DOMINION NUCLEAR CONNECTICUT, INC.
MILLSTONE POWER STATION UNIT 2
RESPONSE TO REQUEST FOR ADDITIONAL INFORMATION FOR
PROPOSED LICENSE AMENDMENT REQUEST REGARDING
SMALL BREAK LOSS OF COOLANT ACCIDENT REANALYSIS (CAC NO. MF6700)

**RESPONSE TO REQUEST FOR ADDITIONAL INFORMATION FOR LICENSE
AMENDMENT REQUEST REGARDING SMALL BREAK LOSS OF COOLANT
ACCIDENT REANALYSIS**

**DOMINION NUCLEAR CONNECTICUT, INC.
MILLSTONE POWER STATION UNIT 2**

Figure 1: Primary and Secondary System Pressure – 3.79-inch Break

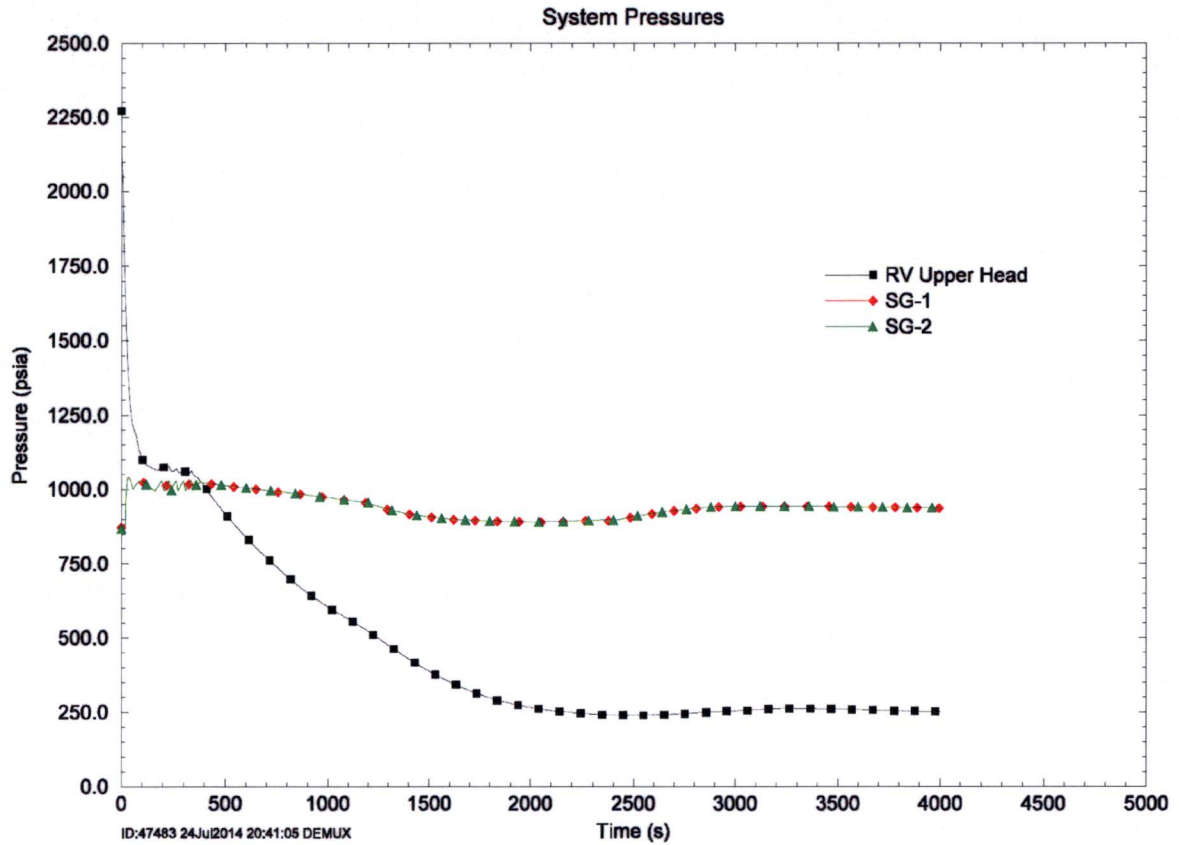
As this is the first plant-specific application of this NRC-approved Small Break Loss of Coolant Accident (SBLOCA) method and for the staff to gain a better understanding of the SBLOCA phenomena for the transition break (3.79-inch diameter break) case, please provide the following six plots for the transition break that were provided for the limiting break (3.78-inch diameter break):

Figure 4-3: Primary and Secondary System Pressure

Figures 1 through 6 provide the requested plots for the 3.79-inch transition break.

Figure 2: Loop Seal Void Fraction – 3.79-inch Break

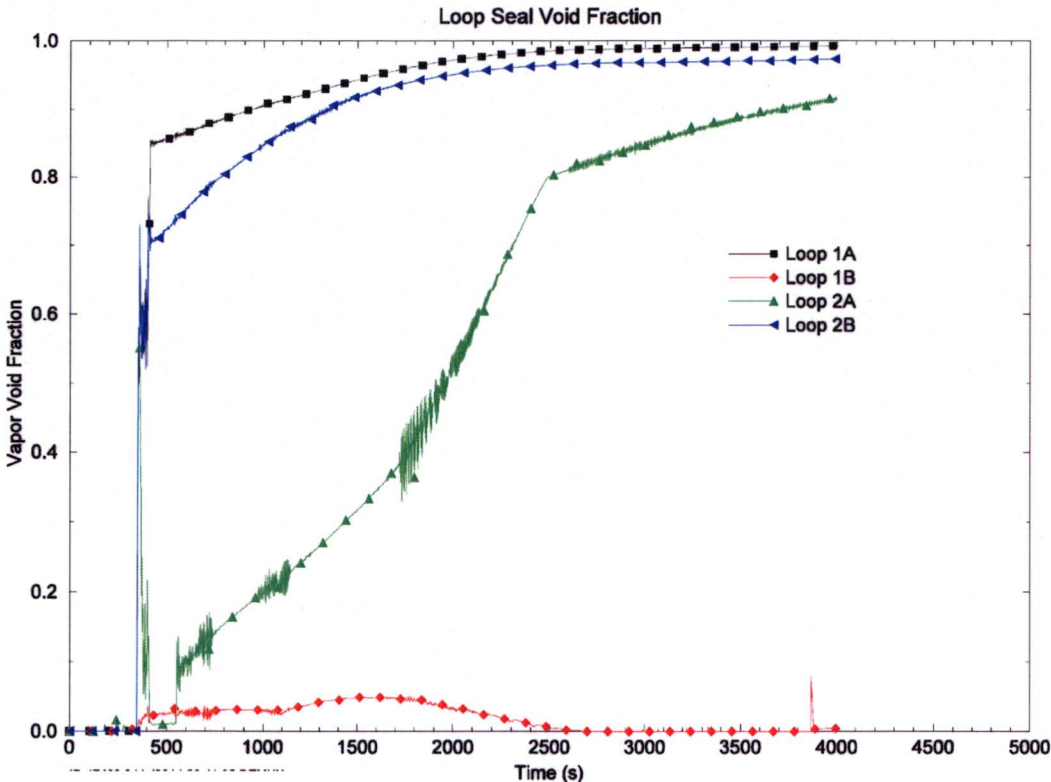
Figure 4-6: Loop Seal Void Fraction

Figure 3: Inner and Outer Core Collapsed Liquid Level – 3.79-inch Break

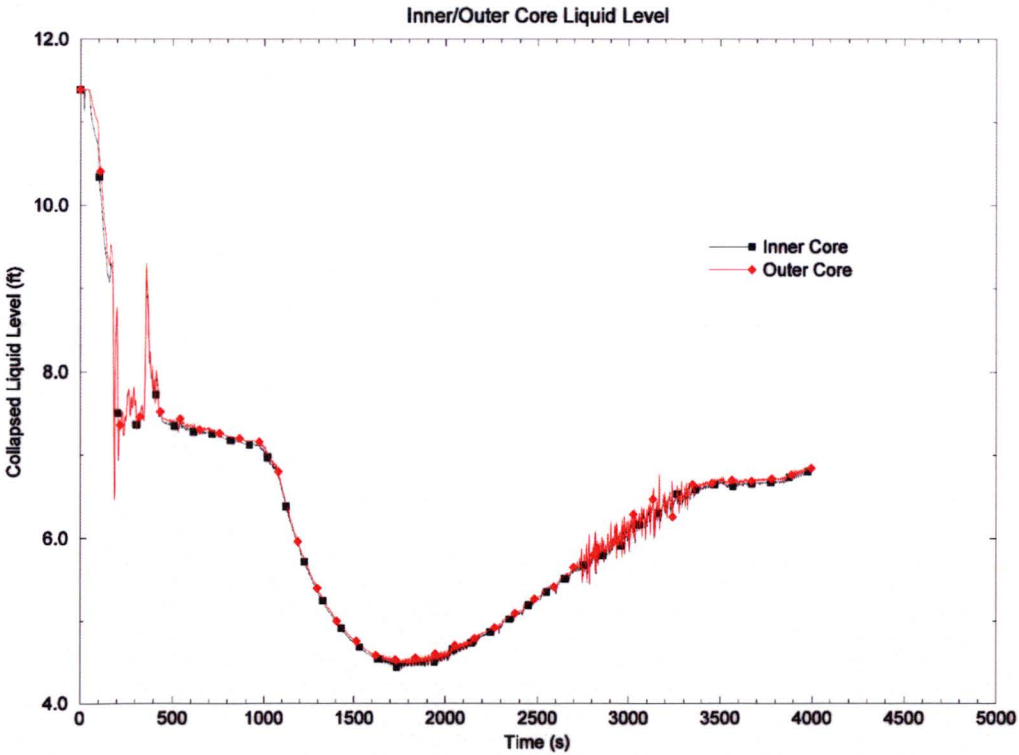
Figure 4-9: Inner and Outer Core Collapsed Liquid Level

Figure 4: Integrated Break Flow and ECCS Flow – 3.79-inch Break

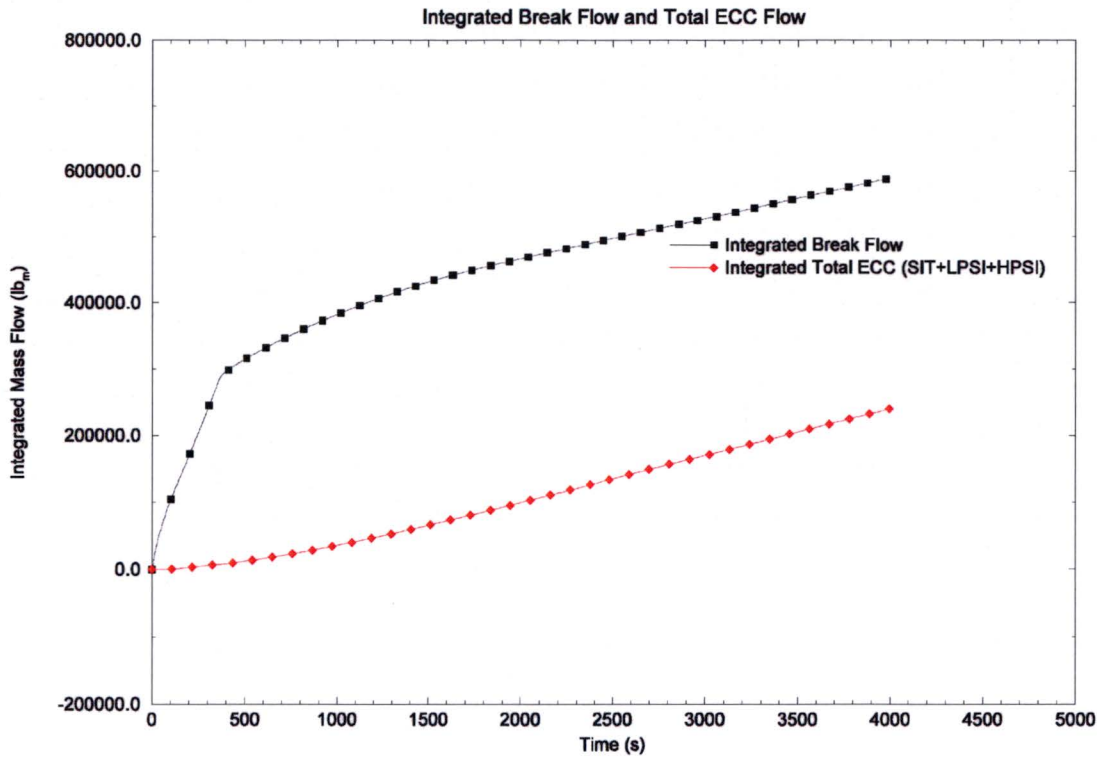
Figure 4-19: Integrated Break Flow and ECCS Flow

Figure 5: Hot Assembly Mixture Level – 3.79-inch Break

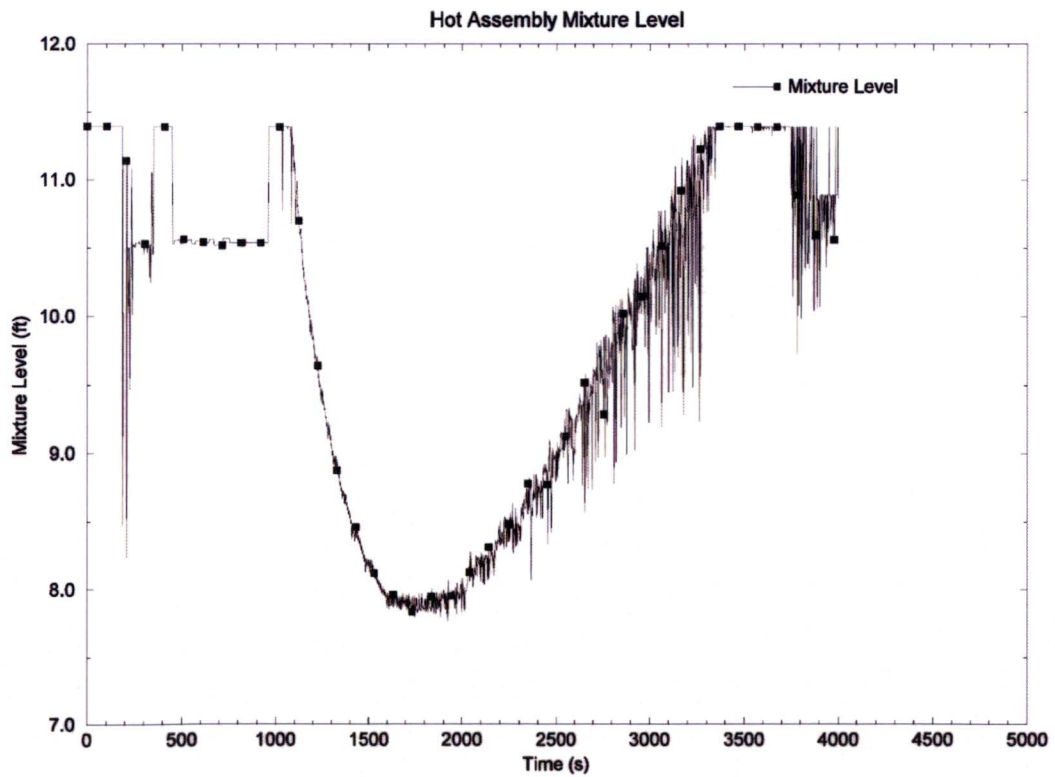
Figure 4-21: Hot Assembly Mixture Level

Figure 6: Peak Cladding Temperature at PCT Location – 3.79-inch Break

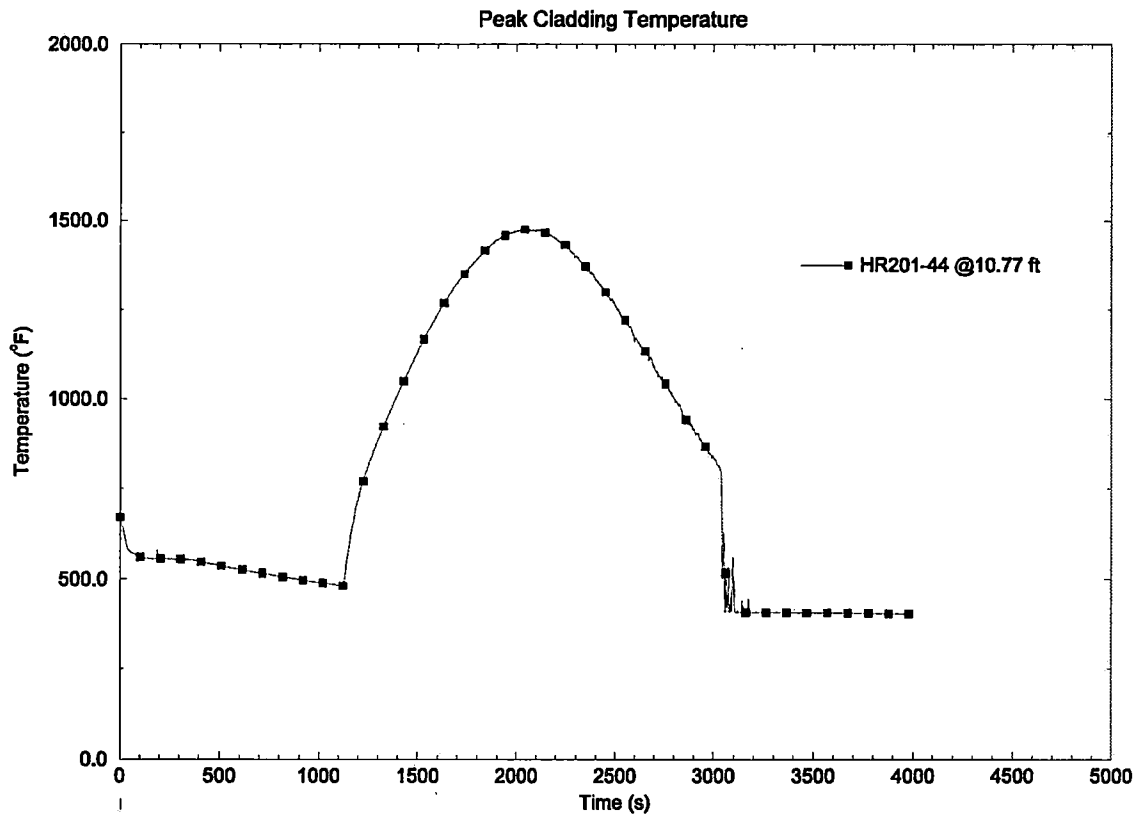
Figure 4-22: Peak Cladding Temperature at PCT Location

Figure 7: Peak Cladding Temperature at PCT Location – 3.78-inch Break, Zirc-4 Cladding

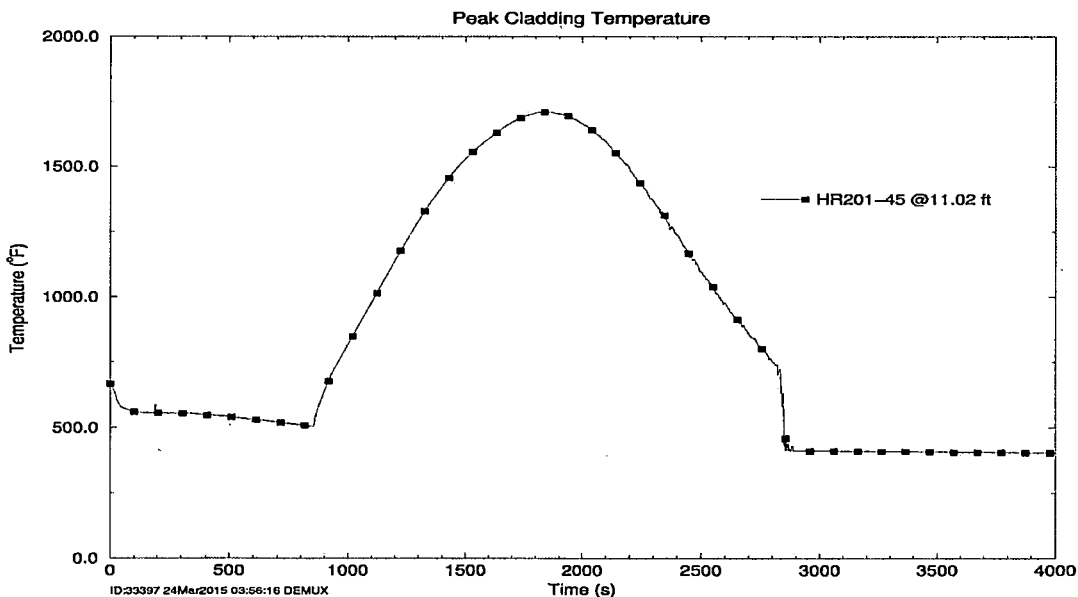
- a. *Please identify which break sizes were rerun and provide their associated PCTs. Also, please provide the PCT vs. time plot for the limiting case.*

- a. The break sizes and associated PCTs for the Zirc-4 cladding evaluation are listed in Table 2. The PCT vs. time plot for the limiting case is shown in Figure 7.

Break Diameter (in)	3.76	3.78	3.785	3.79	3.90	4.00
PCT (°F)	1646	1711	1682	1541	1586	1677
